ALASKA NATURAL GAS TRANSPORTATION SYSTEMS

Final Environmental
Impact Statement

FEDERAL POWER COMMISSION STAFF

VOL. IV
COMMENTS AND RESPONSES
PART II

Figure 20. Wave Roses-Offshore Point Conception Station 5

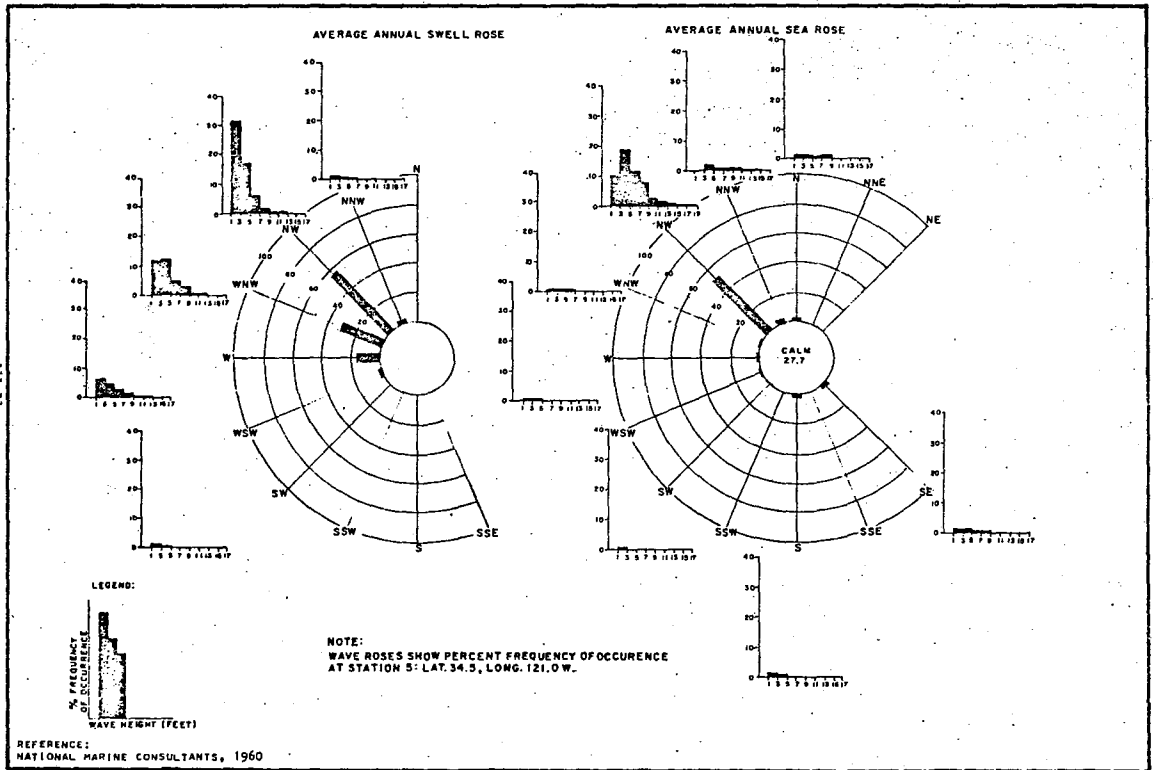
Page III - 73 - Attached is a corrected version of Figure 20, Wave Roses.

Comment accepted. The following revised Figure 20 should replace Figure 20 in Volume III of the DEIS.
